80-02000-2

80-8200

<b>CARVIN</b>		12340 World Trade Drive San Diego, CA 92128 (619) 487-1600 FAX 487-6629
<b>DCM 1500/2000</b>		
DRAWN BY: Craig R. Hockenberry	DATE: 17MAR97	
APPROVED:	DATE:	
PCB NO: <b>30-02000</b>	REV: <b>I</b>	
ASSY. NO: <b>80-01500</b> <b>80-02000</b>	REV: <b>J</b> <b>J</b>	
REVISED BY: <b>C. MCEUEN</b>	DATE: <b>13APR98</b>

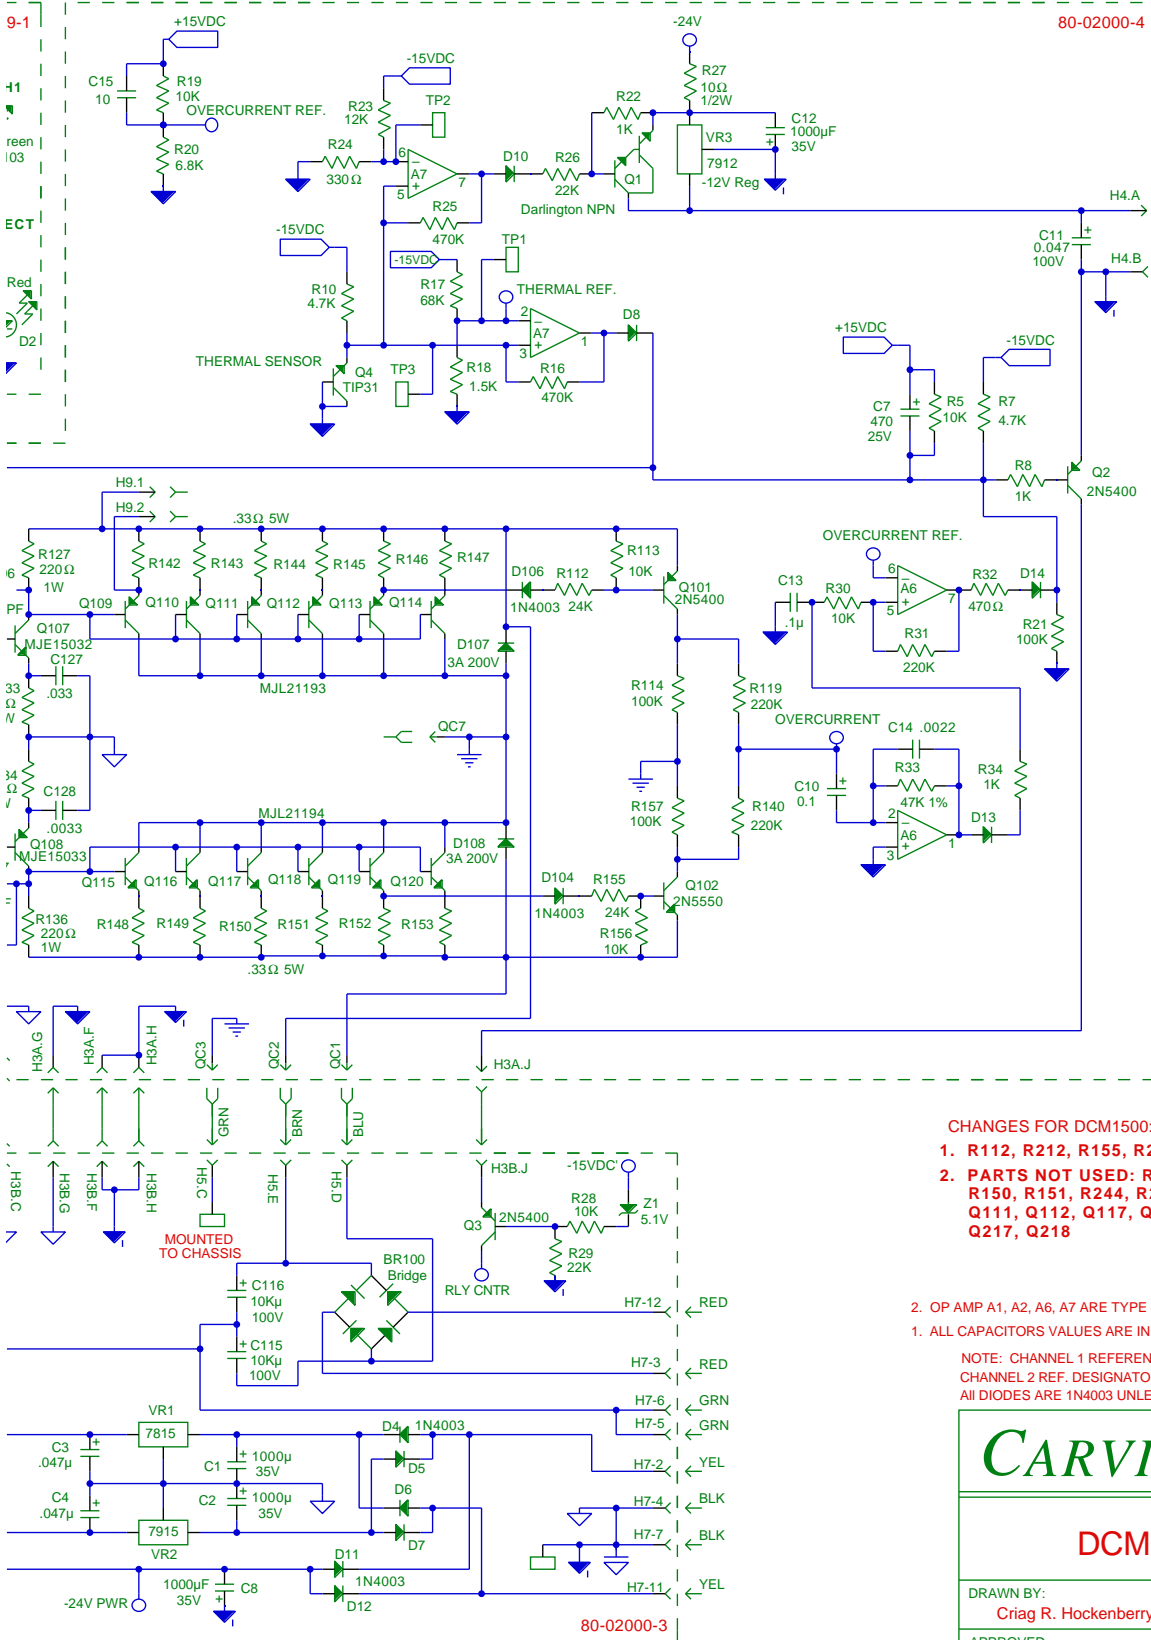
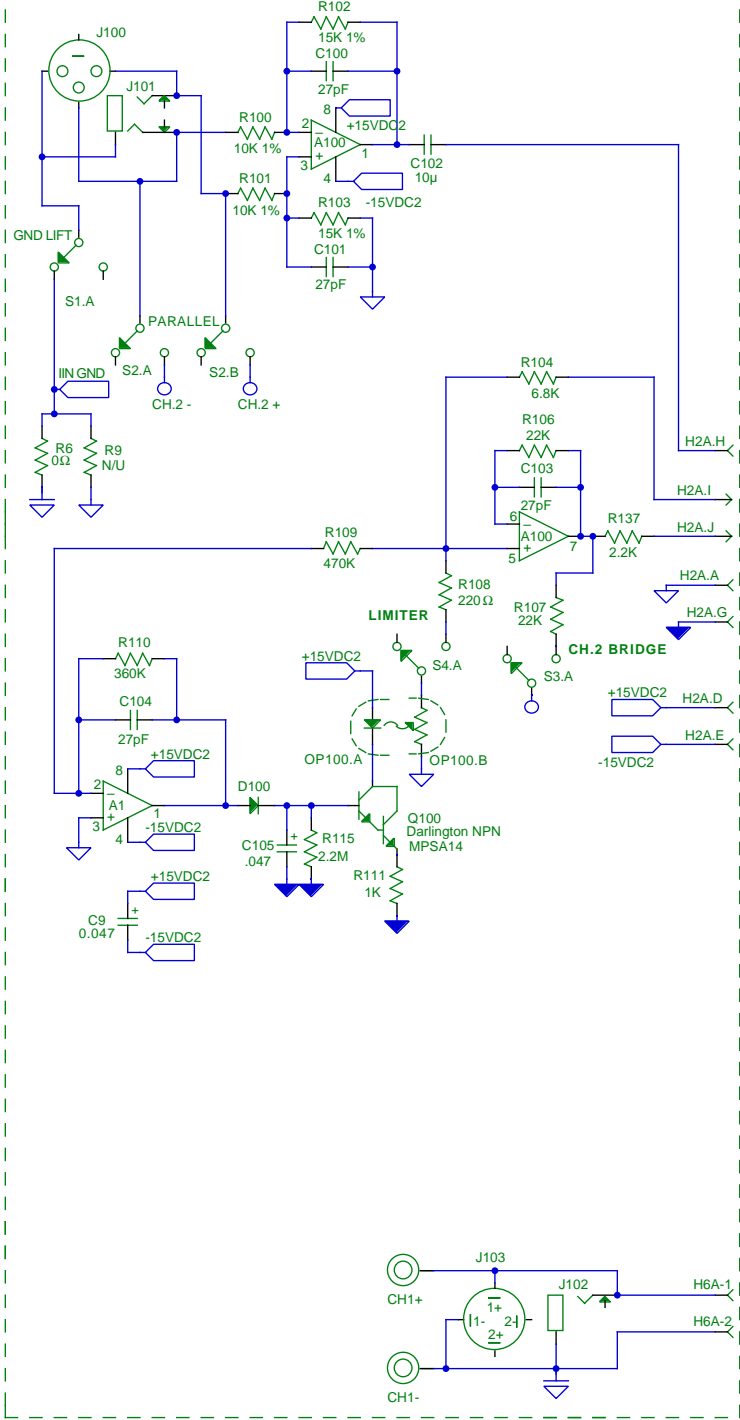
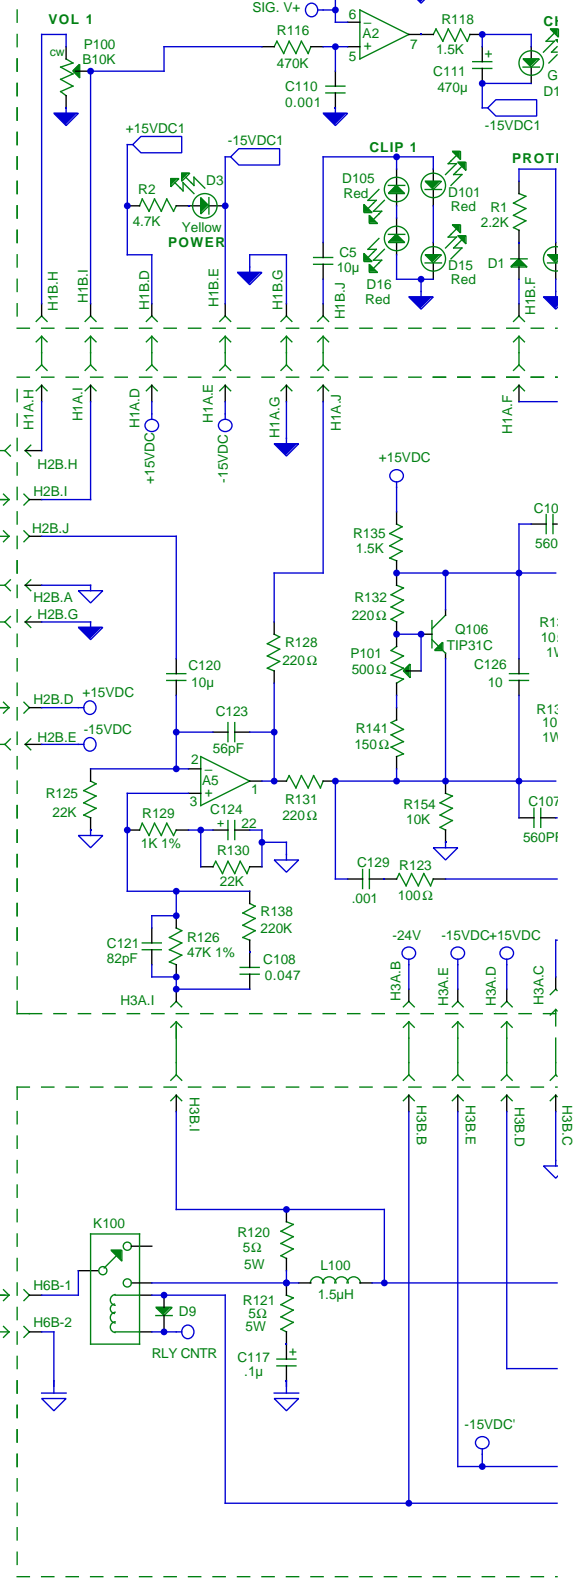
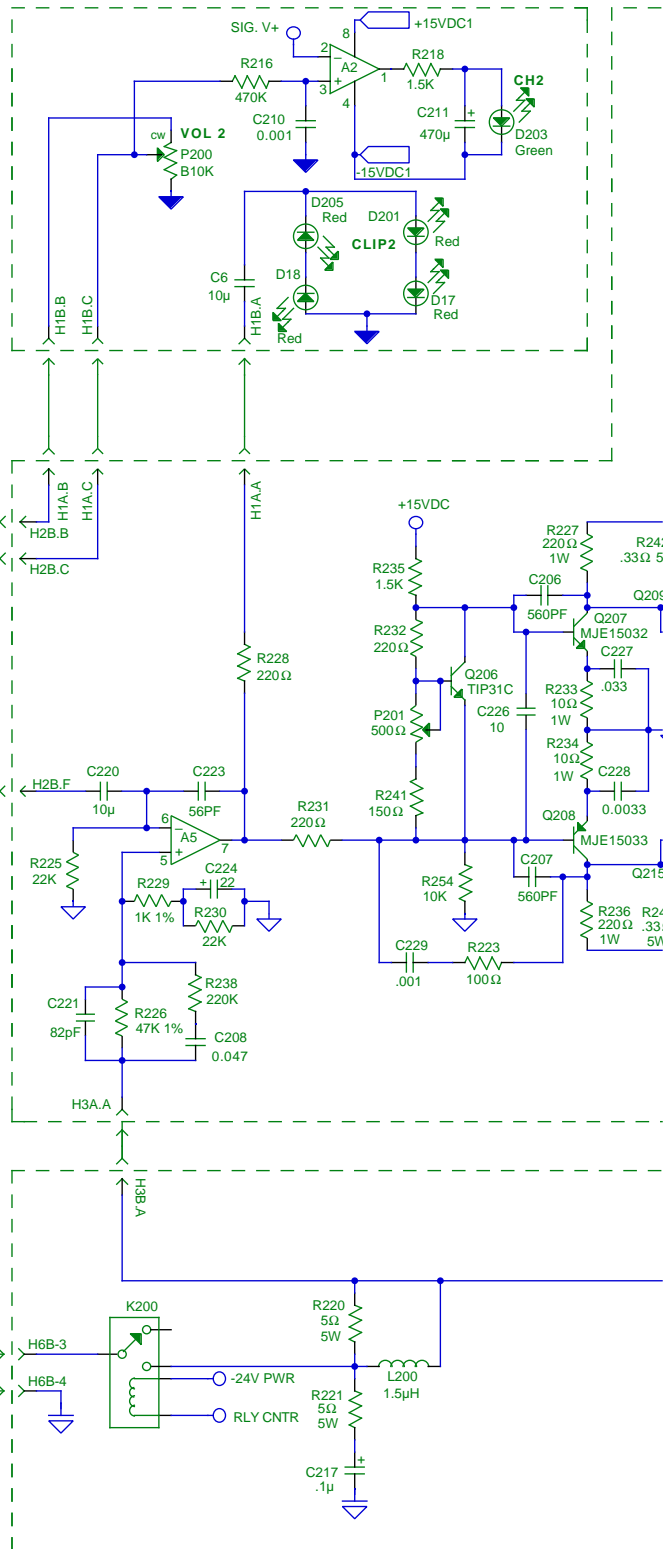
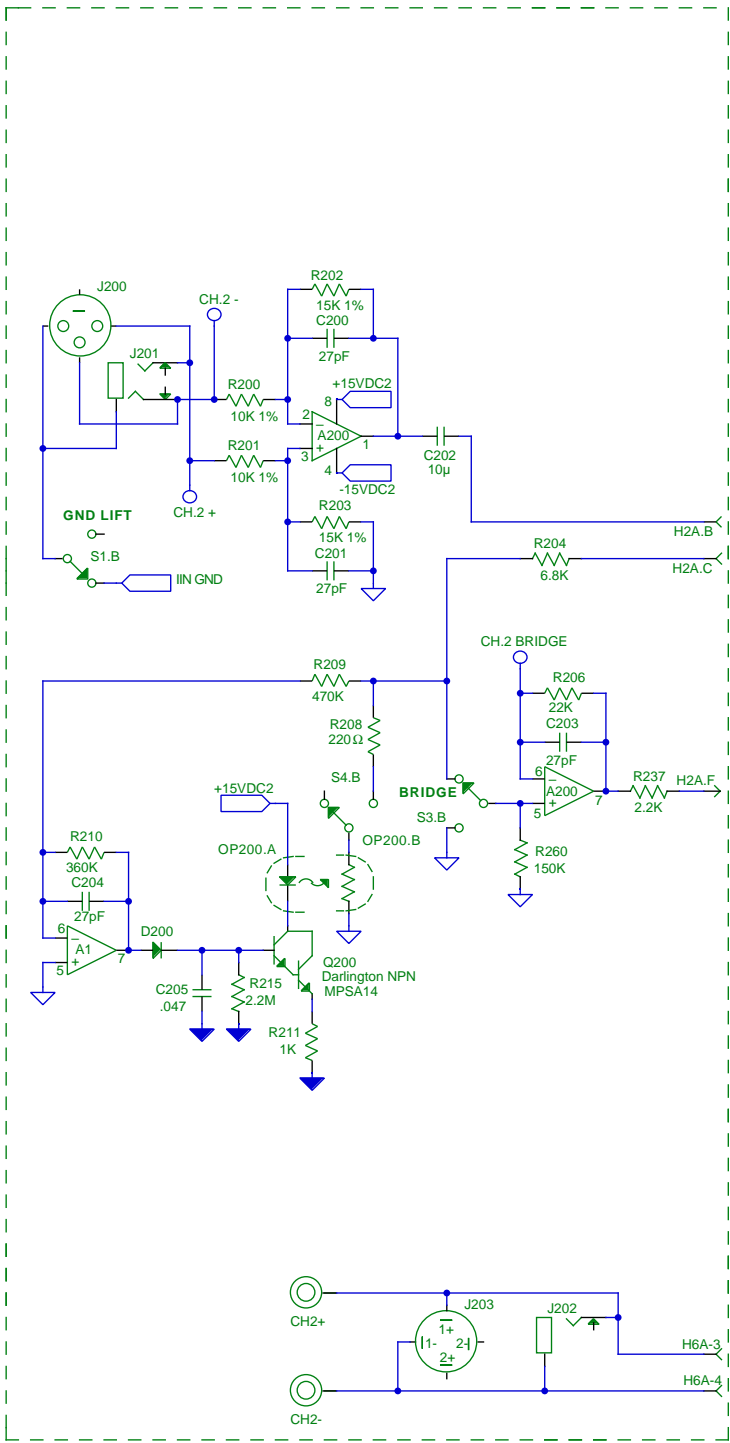
Revisions from D:

- H2 F&J REVERSED, fixed
- Drill sizes enlarged on relays and stereo jacks.
- Remove R139, R239
- Signal LED to post Volume control.
- Add 100K R across C105, C205.
- Remove R105, R205.
- VR3 to be type 7912 (-12V).

CHANGES FROM REV (E):

- REMOVE D102, D202
- Change ground on C111, C211, D103 and D203 to -15VDC.
- Added four red LED's to the clipping indicator circuit
- Relocated R141 and R241 to series
- Value change on R131 and R231

CHANGES FROM REV (F):

- Added test points TP1, TP2, TP3.
- Added test Headers H8, H9.
- Re routed ground from H7.4 to C1/C2.
- PCB to Rev (G)

CHANGES FROM ASSEMBLY REV (G):

- R112, R155, R212, R255 to be 24K
- Input and Feedback resistors to 1%.
- PCB stays Rev (G)

CHANGES FROM ASSEMBLY REV (H):

- Ground from H7 to C1/C2 enlarged.
- PCB mounts @ P100, P200 removed. Proto only PCB (H)

CHANGES FROM ASSEMBLY Rev (I):

- C111 to be between R118 and D103.
  - C211 to be between R218 and D203.
  - Dual trimmer pots (P101A, P201A).
- PCB Updated to (I)

CHANGES FOR DCM1500: 80-01500

- R112, R212, R155, R255 ARE 33K.
- PARTS NOT USED: R144, R145, R150, R151, R244, R245, R250, R251, Q111, Q112, Q117, Q118, Q211, Q222, Q217, Q218
